Response to comments on Manuscript egusphere-2025-6543 (RC2)

Reply on RC2:

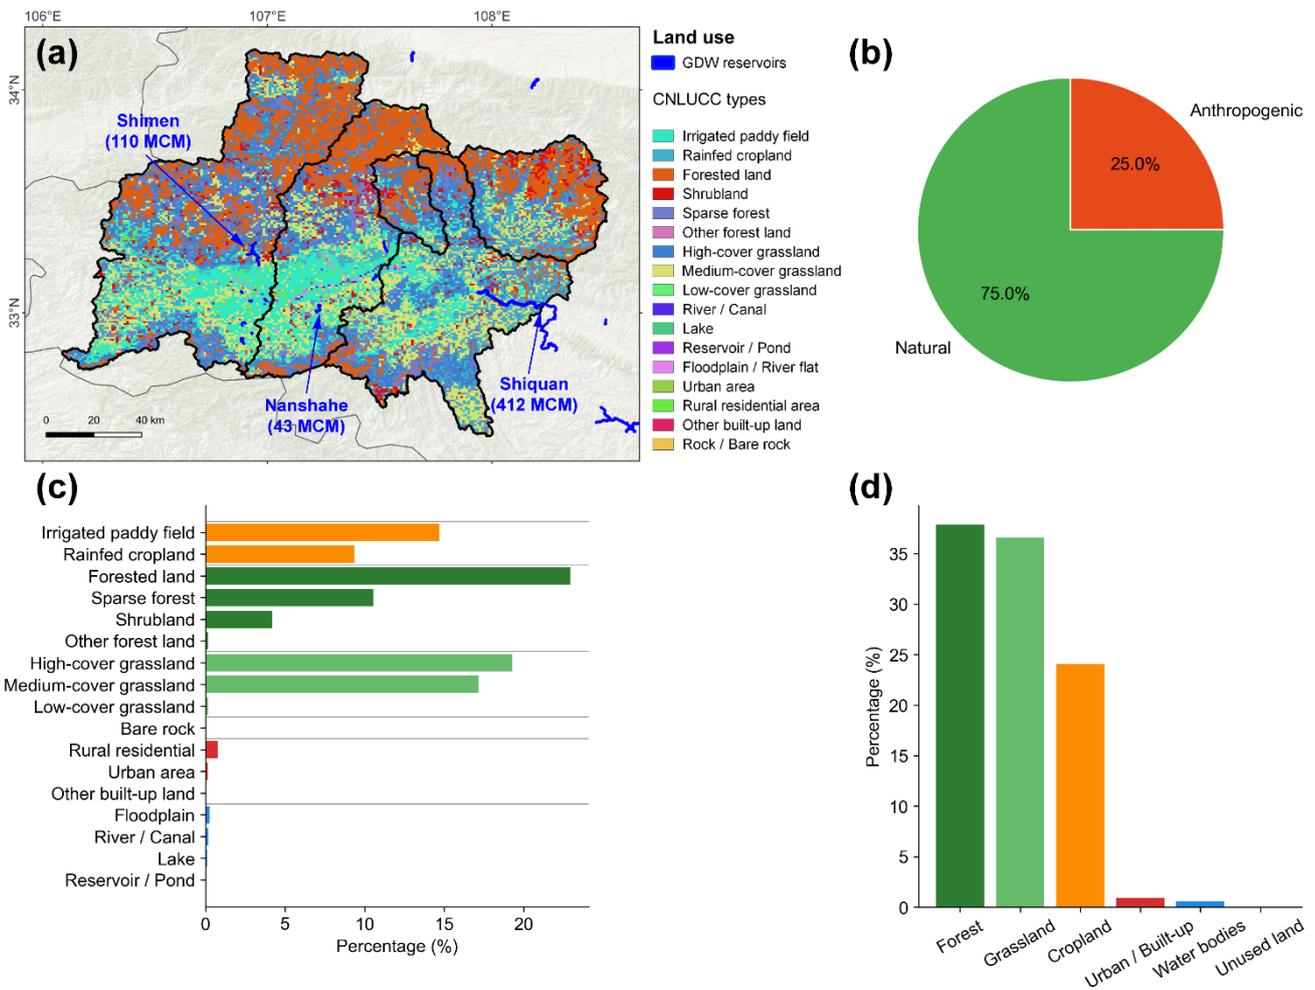
RC1-5/ Study Area: Can you provide a land use analysis on the Upper Han River Basin to visualize the amount of anthropogenic vs natural landscape? Please include an explanation of the presence or absence of impoundments, dams, or reservoirs in the watershed.

R/ We thank you for this valuable comment, which is very helpful for clarifying the characteristics of the study basin. In response, we have collected data from **CNLUCC (China multi-period land use remote sensing monitoring; Xu et al., 2018) and GDW (Global Dam Watch; Lehner et al., 2024) datasets** to conduct a land use analysis and spatial visualization, as shown in Fig. S1.

Our analysis shows that **natural land use dominates** the basin, accounting for approximately 75% of the area. Anthropogenic hydraulic structures are scarce, with only three reservoirs: Shimen and Nanshahe, located in the upper and mid-reaches, have maximum storage capacities of 110 and 43 MCM (million cubic meters), respectively, which are negligible for hydrological modelling. The only potential source of uncertainty is the Shiquan reservoir, with a maximum storage of 412 MCM, situated near the basin outlet. However, it **operates on a daily regulation scheme** and is primarily used for hydropower generation and flood control. As the model aims to simulate daily streamflow, **its impact on the simulated discharge is expected to be minimal**. This is further supported by **the large annual runoff at the station (~10.8 billion cubic meters), which substantially exceeds the reservoir storage capacity**. In light of these considerations, the reservoir is not explicitly represented in the model, and its influence is assumed to be negligible. It is worth noting that, compared with the UHRB, the Han River basin downstream of Shiquan contains many hydraulic structures along the mainstem, such as Xihe, Ankang, Dongwuyan, and Danjiangkou reservoirs, whereas anthropogenic impacts in the UHRB are comparatively minimal.

We have added the corresponding analysis and figure in the revised manuscript, attached below for your review.

Figure S2. Refinement of the MPR-based regionalization of RVIC parameters. Spatially distributed velocity and diffusion coefficients are estimated using transfer functions (Table 2) driven by topographic attributes and calibratable g-parameters.

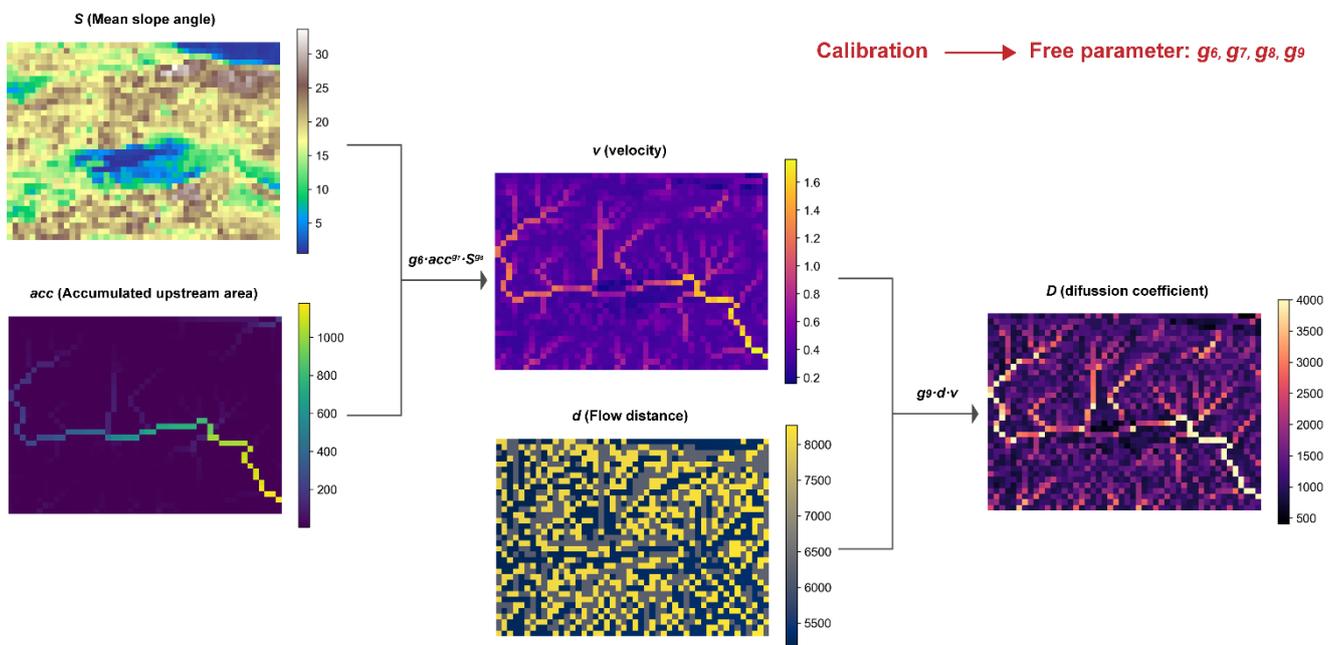
RC1-6/ Methods: Figure 2: Could you add the additional steps of RVIC parameter refinement using MPR technique here?

R/ Thank you for your valuable suggestion. We recognize that the lack of a schematic illustration may reduce the transparency of the RVIC parameter refinement regionalization. To address this, we have included a schematic diagram to better clarify the methodology. To maintain the clarity and independence of the figures, this addition is presented as Fig. S2 in the Appendix rather than being incorporated into Figure 2. The newly added figure and the revised description are provided below for your review.

Line 248:
Nonetheless, we use the MPR technique here to enhance the spatial representation of these two parameters by linking them to topography (Fig. S2~~Table. 2~~).

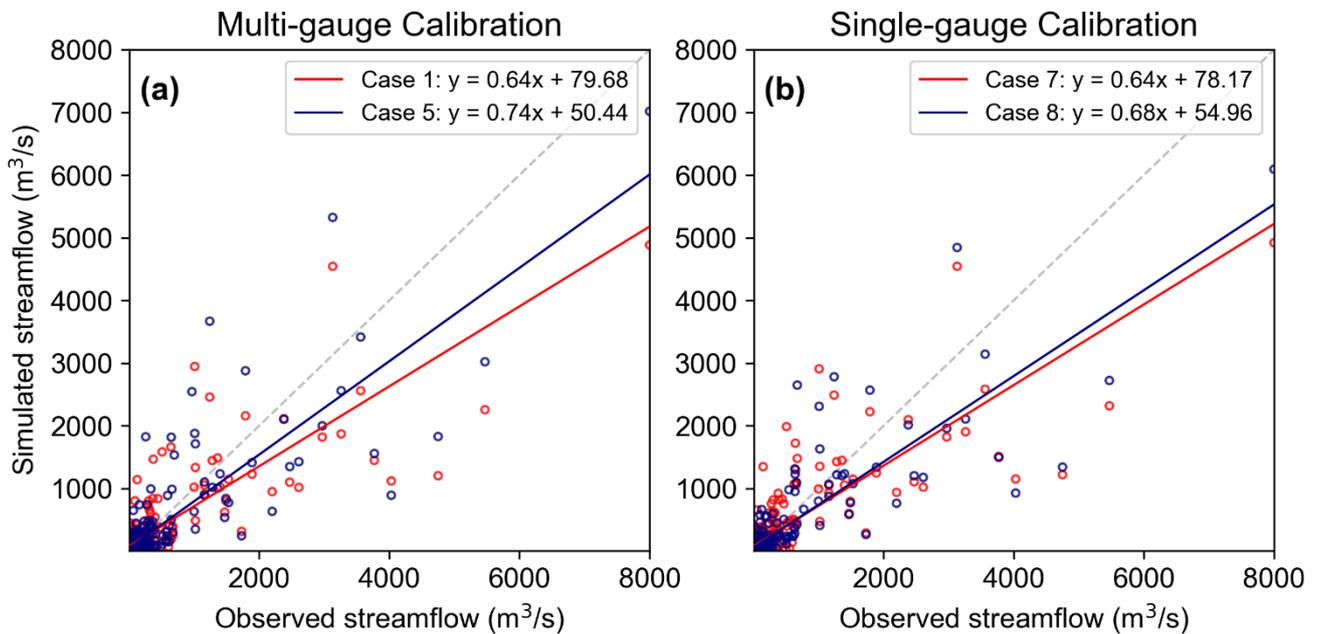
RC1-7/ Results: Figure 4: The regression plot between the observed and simulated streamflow makes it hard to visualize the patterns of the majority flow observations below 100m3/s, and appears to rely on a few of the larger flow metrics. I recommend a random thinning to effectively visualize the patterns in the majority of below 1000 m3/s.

R/ This is a very professional suggestion regarding the presentation. Following your advice, **flows below 1000 m3 s-1 were randomly thinned** to improve visual clarity. Furthermore, we have **added a scatter comparison in logarithmic space** in the Supplement, which clearly illustrates the simulated behavior

discussed in the manuscript, showing that the distributed parameterization improves high-flow simulation while exacerbating overestimation at low flows. The figure color scheme has also been adjusted to comply with journal requirements. The revised captions and figures are provided below for your review.

Figure 6. Relative contributions of four major water balance components for different case configurations during the validation period.

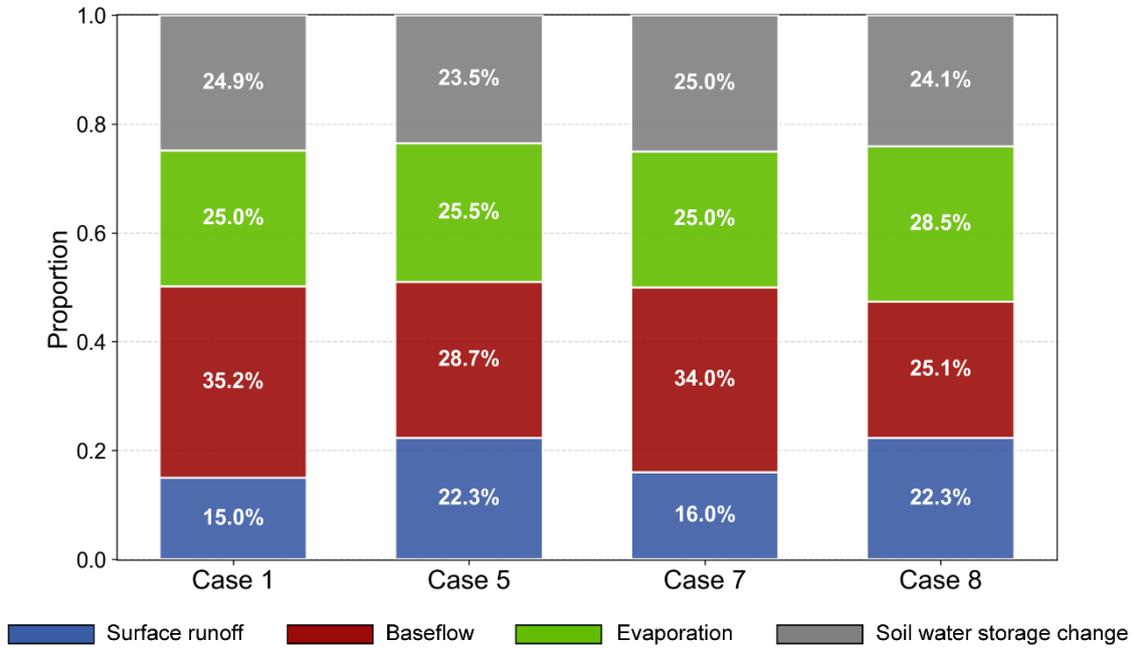
RC1-8/ Figure 6: I find the pie chart hard to visualize, and I would recommend converting to nested barcharts.

R/ Thank you for your suggestion. We have replaced the pie chart with a nested bar chart that provides a clearer comparison. The revised figure and corresponding modifications are provided below for your review.

This allows us to derive the relative contributions of each component, which are summarized as a nested barchart~~pie chart~~ in Fig. 6.

Figure 7. Spatial distribution of differences in (a, b) surface runoff and (c, d) baseflow volumes between the two parameterization schemes over the validation period. Differences are calculated as spatially explicit minus uniform parameterization.

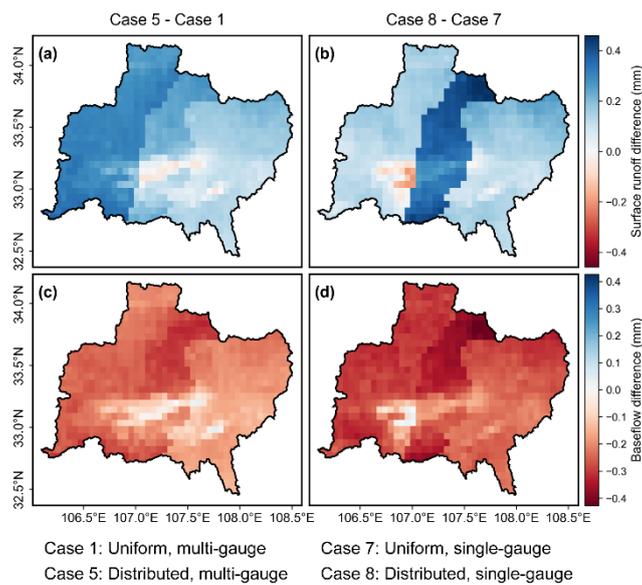
RC1-9/ Figure 7: I recommend adding the explanation of Case 1, 5, 7, and 8 in the caption so readers don't have to refer to table 4 in order to interpret the results.

R/ Thank you for your valuable comment. Following your suggestion, we have added additional descriptions of each case below Fig. 7 to improve readability and facilitate interpretation.

Case 1: Uniform, multi-gauge
Case 5: Distributed, multi-gauge

Case 7: Uniform, single-gauge

Case 8: Distributed, single-gauge
